**Petition for Modification
Tanager Battery Energy Storage System Project**

Data Response Set 6

**Los Esteros Critical Energy Facility
03-AFC-02C**

Subject: Noise Technical Memo for the Los Esteros Critical Energy Facility (03-AFC-02C) Tanager Battery Energy Storage System (BESS) Project

Figure 1. Project Site, Noise-Sensitive Areas, and Ambient Noise Monitoring Locations

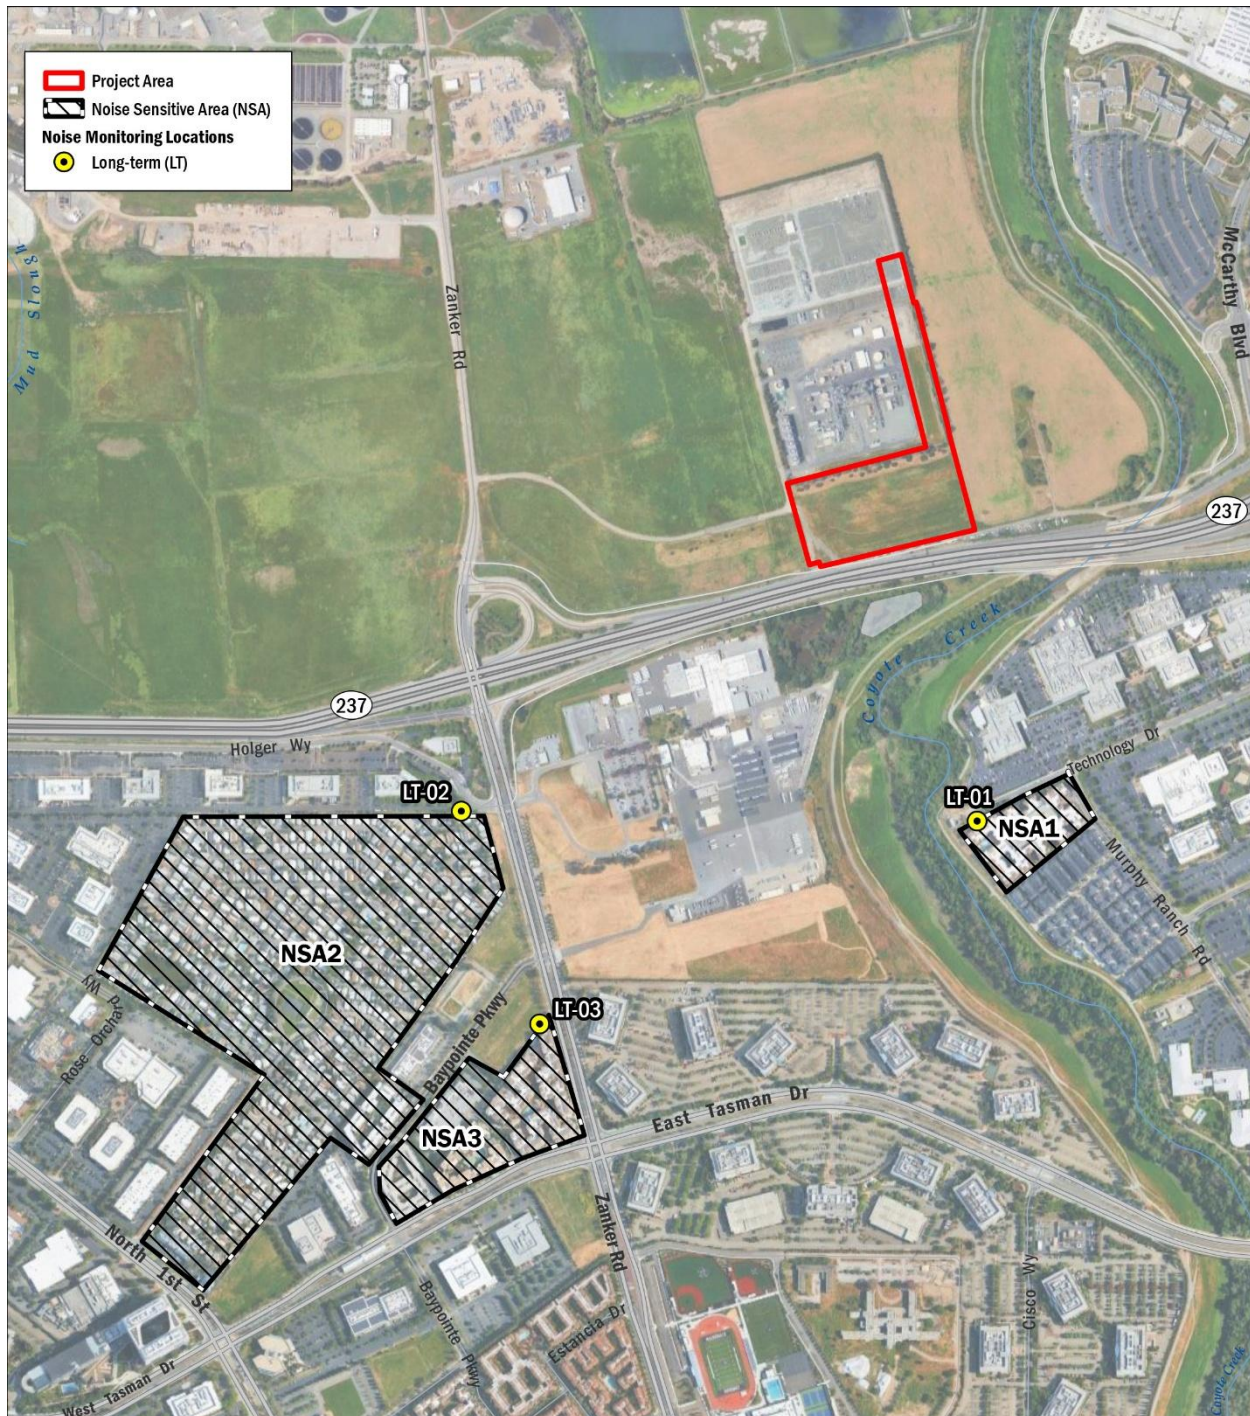
Data Request A117: Please indicate the specific sensitive receptors and provide a minimum 25-hour ambient noise survey (in units of hourly Leq) at the sensitive receptors for the project identified in TN 268268, Figure 4.

The California Energy Commission’s (“CEC”) Final Decision for the Los Esteros Critical Energy Facility II Phase II (“LECEF Final Decision”) identified the nearest sensitive noise receptor to the site as residences located approximately 1,100 feet (0.2 miles) southeast of the site at 1657 Alviso-Milpitas Road. (LECEF Final Decision, p. 314.) The vacant residence was demolished in 2021. (San Jose Data Center Small Power Plant Exemption Commission Decision, p. 4.5-9.) There are no other residences or sensitive receptors within 1,000 feet of the Project site on the north side of the Southbay Freeway (“SR 237”). Other sensitive receptors are separated from the Project site by SR 237 and are located at least 1,500 feet away to the south and southwest. (Attachment DR-A117; See also, Attachment DR-A8, Figure 4, TN: 268268.)

The project site is immediately south of the existing LECEF and north of SR 237. The surrounding area includes existing energy infrastructure, transportation facilities, and commercial and industrial development. Residential neighborhoods are present south of SR 237. Figure 1 identifies the project site, three noise-sensitive areas (NSAs), and the associated long-term ambient noise monitoring locations.

- NSA1, located approximately 0.3 mile southeast of the project, includes multi-family residential uses represented by LT-01.
- NSA2, located approximately 0.5 mile southwest of the project near the Zanker Road/Silicon Valley Village area, includes single-family residential uses represented by LT-02.
- NSA3, located approximately 0.6 mile southwest of the project, includes multi-family residential uses represented by LT-03.

The monitoring locations provide representative existing noise conditions near the identified NSAs, as identified in Figure 1. Ambient monitoring at LT-01, LT-02, and LT-03 represents the nearest portion of NSA1, NSA2, and NSA3, respectively (Figure 1).

Figure 5. CadnaA-Predicted Project-Only Operational Noise Contours (Leq, dBA)

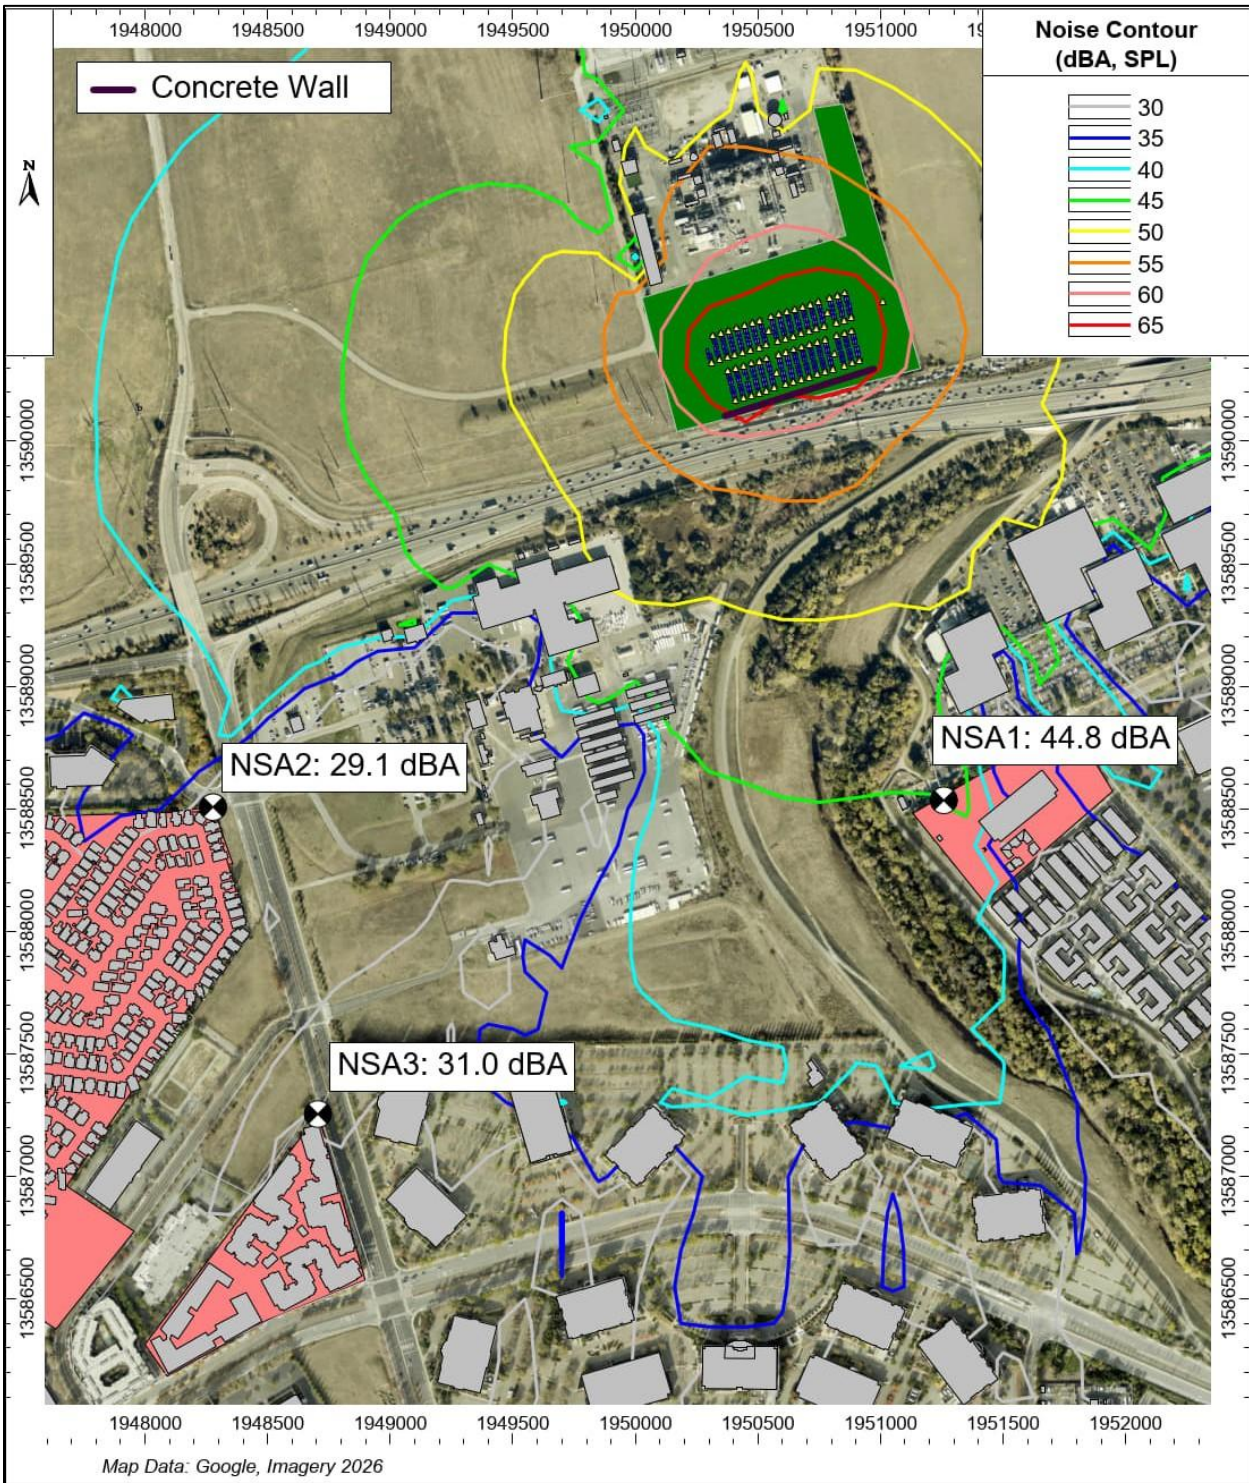
Data Request A 118. Please provide an operational noise contour map or tabulated values of estimated noise levels of the project (in units of hourly Leq) at the sensitive receptors and at the project boundary.

RESPONSE: An operational noise contour map is provided as Attachment DR-A117, Figure 5.

Figure 5 presents the CadnaA-predicted project-only operational noise contours for the modeled equipment inventory. The contours account for the distributed equipment locations, atmospheric and

ground attenuation, intervening buildings, terrain, and the 6-foot-high concrete wall along the southern project boundary. The contours represent project-generated sound only and do not include existing roadway traffic or other ambient noise sources. The modeled noise-sensitive receptor predictions are summarized in Table 8, and the representative property-line predictions are provided in Table 10.
